SUMMARY OF CONCERNS IN RELATION TO THE PROPOSED NORTHCONNEX TUNNEL

This is an objection to many aspects of the proposed NorthConnex tunnel.

SECTION A: THE CONNECTIVITY OF NORTHCONNEX SOUTHERN VENTILATION FACILITY AT THE SOUTHERN INTERCHANGE, THE SOUTHBOUND TUNNEL IN PARTICULAR

Figure 5-17 Motorway operations complex

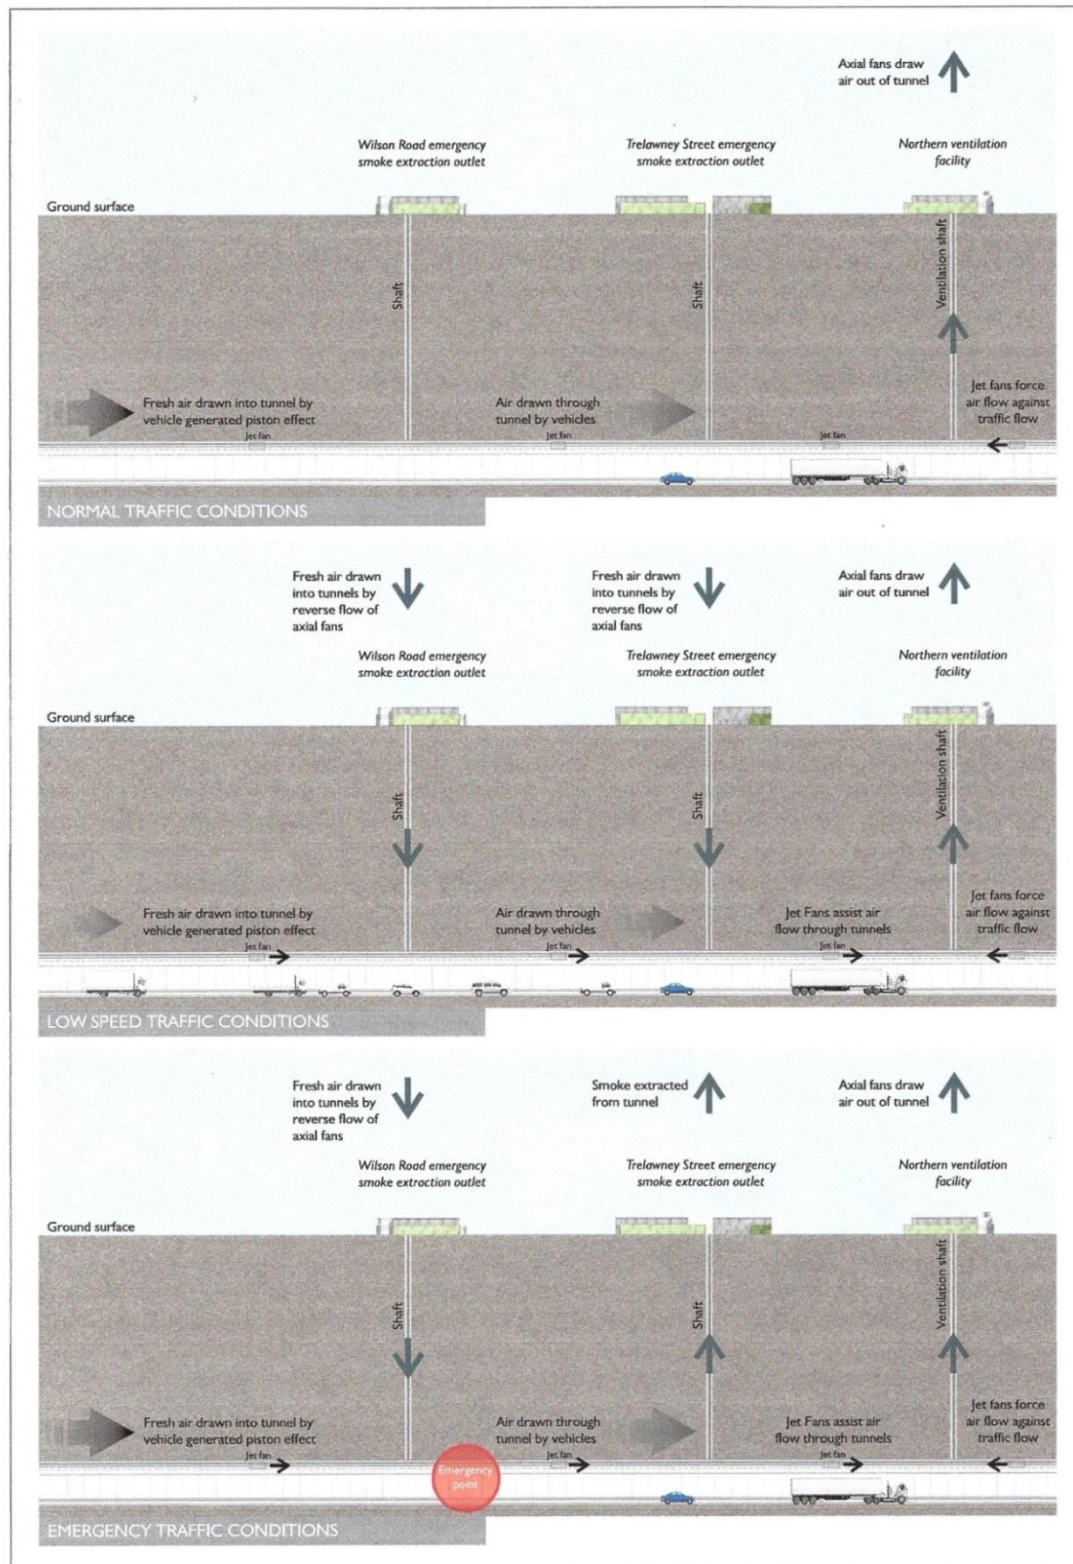
EIS Page 111, *Figure 5-17 Motorway operations complex*

Page 8 below there is no indication of how the ventilation facility will be connected to either the northbound or southbound tunnel, nor is there any indication of how the southbound exit portal onto Pennant Hills Road or the south-west exit portal onto the M2 will be connected.

In each of the above figures for Wilson Road, Trelawney Street, and Northern Ventilation facility, the shafts, emergency smoke extraction buildings, and ventilation facility make a substantial footprint in the construction area; however for the Southern Interchange the ventilation facility is an insignificant part of the construction area. How can this be? The difference in scale does not explain the difference.

We also find it disturbing that in each of the above figures for Wilson Road, Trelawney Street, and Northern Ventilation facility the headings are for “*tunnel support facility operational layout*” and “*ventilation facility operational layout*” but for the Southern Interchange the description is for “*Motorway operations complex*” with no mention of the ventilation facility or the tunnels.

Figure 5-38 Indicative southern interchange construction compound

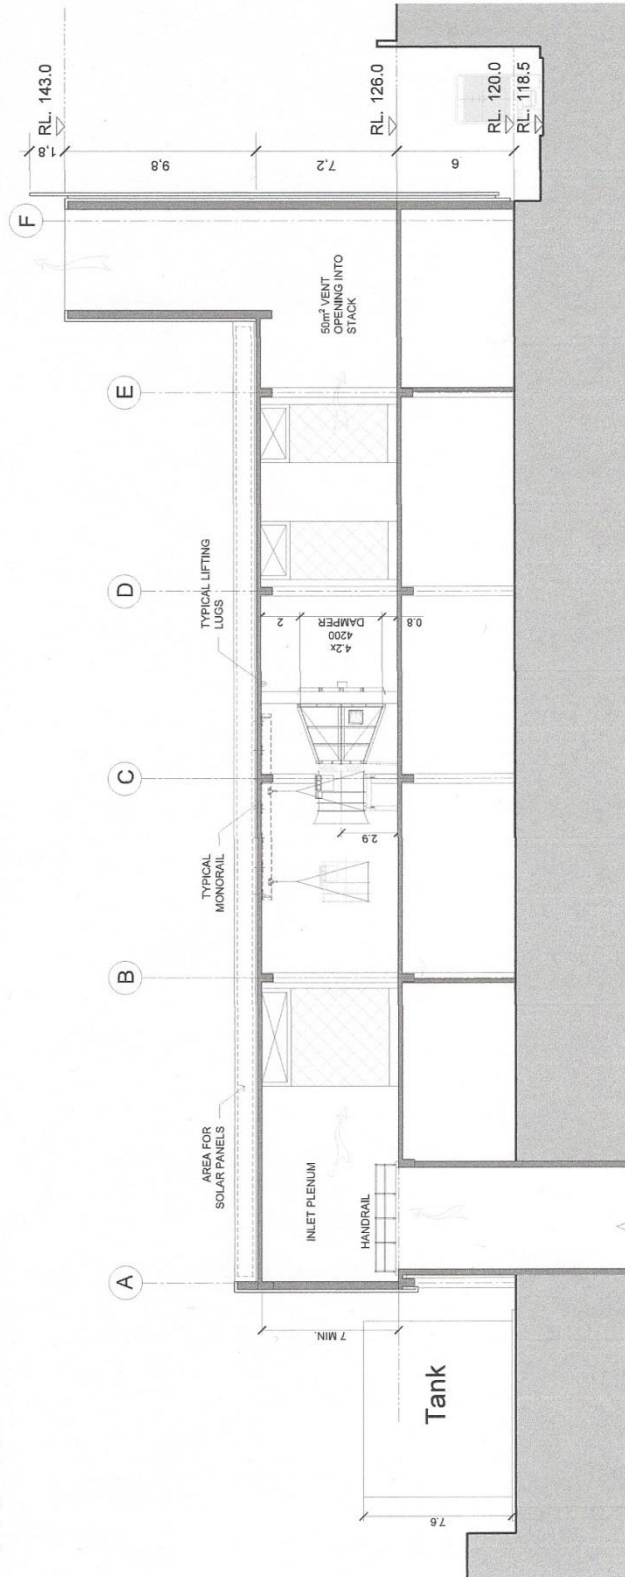
3. EIS Page 189 *Figure 5-38 Indicative southern interchange construction compound* *Page 9 below*

It is ominous that the southern ventilation facility and shaft are completely absent from Figure 5-38.

MOTORWAY OPERATIONS COMPLEX - SOUTHERN VENTILATION FACILITY - SECTIONS
M1-M2-5000-DR-JD-0525

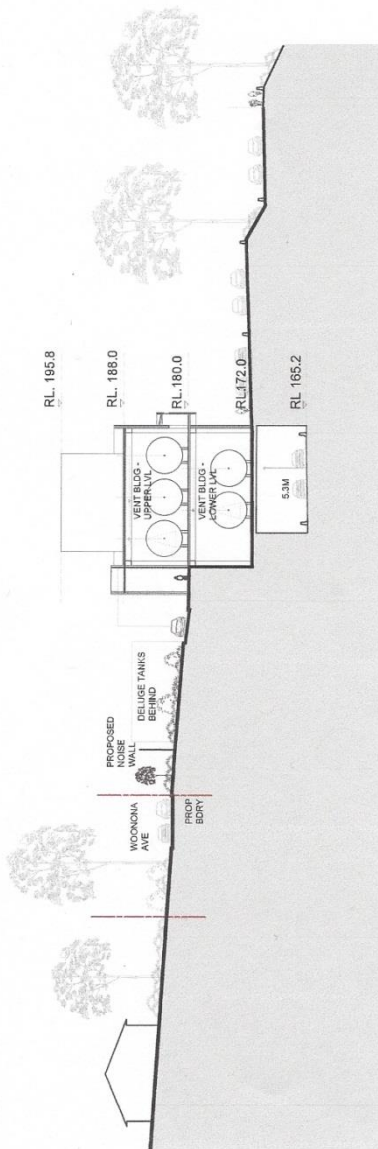
5. *EIS Volume 4, Technical working papers - Urban Design, 6.0 Operational Ancillary Facilities*
EIS Page 99 there is the diagram "Motorway Operations Complex – Southern Ventilation Facility – sections. *Page 10 below* The diagram has the cryptic label "Connection to tunnel TBC". What does TBC stand for? To be considered? Why is tunnel singular? Which tunnel is the diagram referring to northbound or southbound? There is no diagram showing any connection from the Southern Interchange ventilation facility to either the northbound or the southbound tunnel in any way
AND YET

- Diagrams need to be provided showing the inter-relation between the shaft, the ventilation outlet and the motorway operations centre with a clear description of what is to be constructed and how it will operate.
- The community needs irrefutable evidence that the polluted air from the southbound tunnel exit portals will not be allowed to flow like an invisible sewer through West Pennant Hills, North Rocks, Carlingford and Beecroft.
